CITY OF ALBUQUERQUE

**RE: Air Quality Permit No. 3340-RMD ~ New Mexico Terminal Services, LLC
– Construction Permit – 9615 Broadway Blvd. SE**

ATTACHMENT
Public Participation Notification Letter
for New Mexico Terminal Services Permit Application #3340-RMD

Figure 1 – Map Showing All Bernalillo County Census Tracts with a Cancer Risk between 30 and 36 people in one million due to HAP

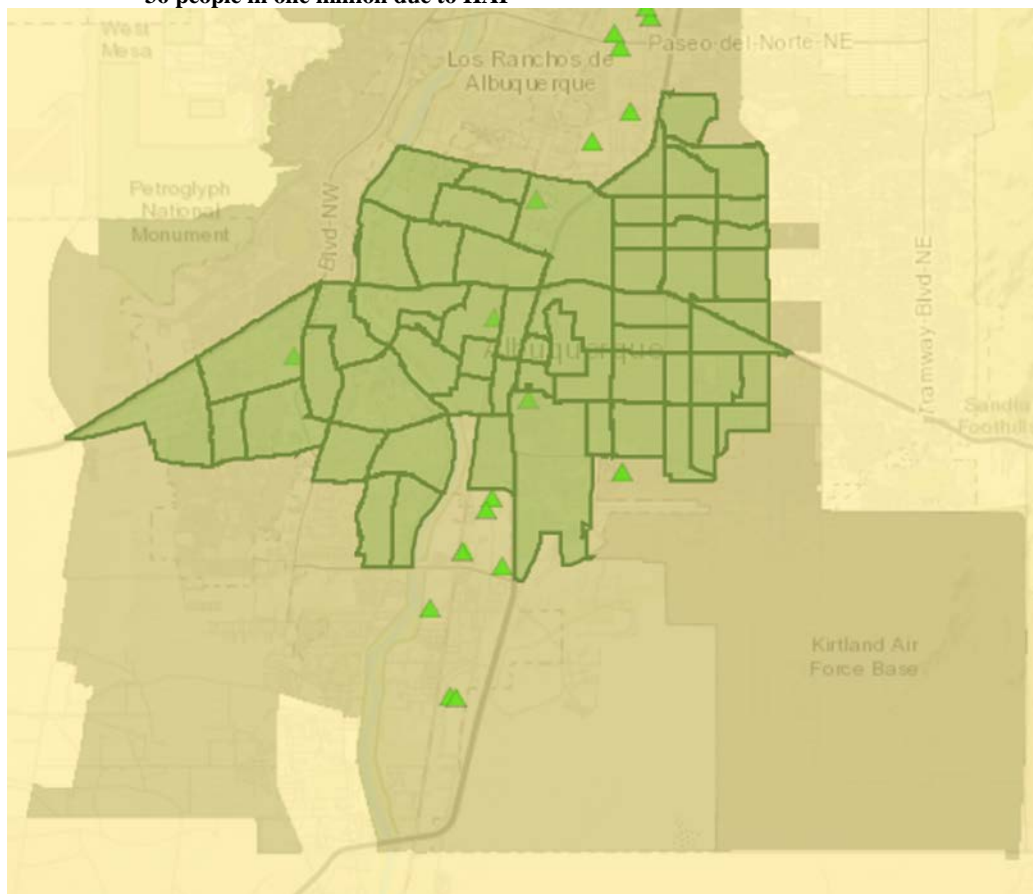
Second, the EPA has developed the National Air Toxics Assessment (NATA) to provide information about the cumulative impacts from HAP. In 2018, EPA released its 2014 National Air Toxics Assessment (NATA). See Fact Sheet at <https://www.epa.gov/national-air-toxics-assessment/2014-nata-fact-sheet>. NATA is a screening tool intended to help EPA and state, local and tribal air agencies determine which areas, pollutants or types of pollution sources need to be examined further to better understand risks to public health. NATA provides broad estimates of the risk of developing cancer and other serious health effects from HAP over census tracts across the country. It does not estimate any person's individual risk.

The census tract where NMTS is located is in Mountain View. That census tract is not among the census tracts identified in Figure 1. The Mountain View census tract (Tract 4001) has a total cancer risk of 26 in one million. This is lower than the Bernalillo County average of 27 in one million and lower than the national average of 30 in one million. NATA is a screening cumulative risk assessment. The information in NATA does not raise concerns about cumulative impacts from HAP where the NMTS activity would be located.

Figure 2 – Map Showing All Bernalillo County Census Tracts with a Respiratory Hazard Index between 0.4 and 0.6.

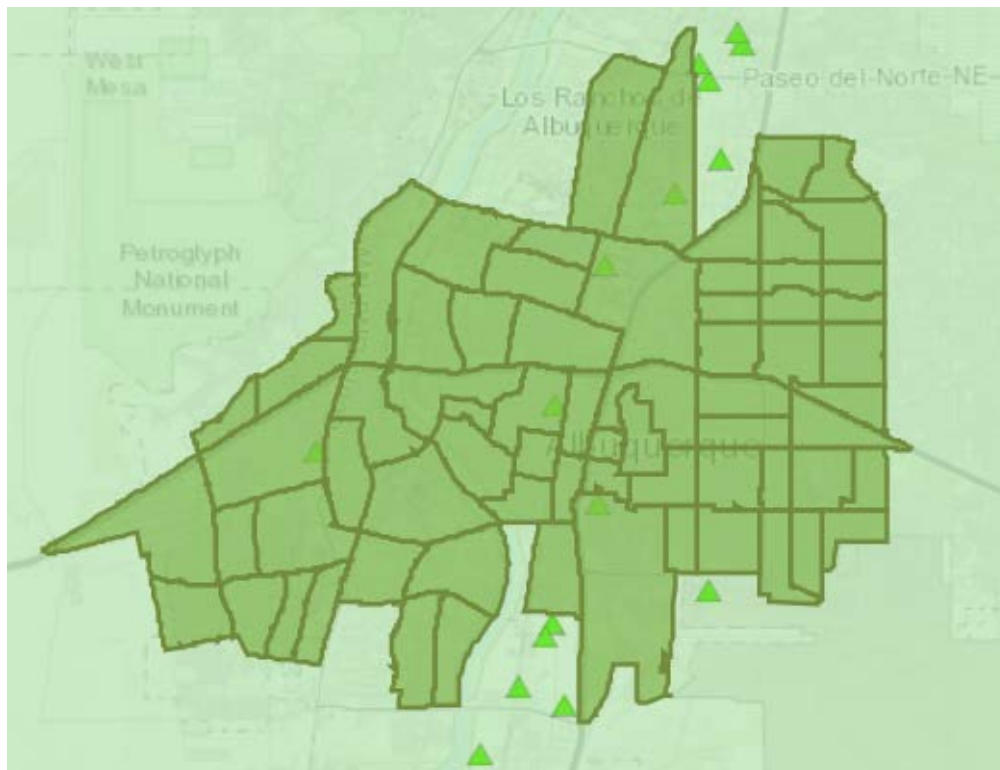
While all Albuquerque-Bernalillo County census tracts are below 1, the urban area has a higher respiratory hazard index than rural areas. Seventy census tracts (out of 159 total) located in the urban core of Bernalillo County have a respiratory hazard index between 0.4 and 0.6. These are higher than the county average but still well below 1. Those seventy urban census tracts are shown in Figure 2 below.

The census tract where NMTS is located is in Mountain View. That census tract is not among the urban census tracts identified in Figure 2. The Mountain View census tract (Tract 4001) has a respiratory hazard index of 0.35. This is lower than the Bernalillo County average of 0.37 and lower than the national average of 0.44. NATA is a screening cumulative risk assessment. The information in NATA does not raise concerns about cumulative impacts from HAP where the NMTS activity would be located.
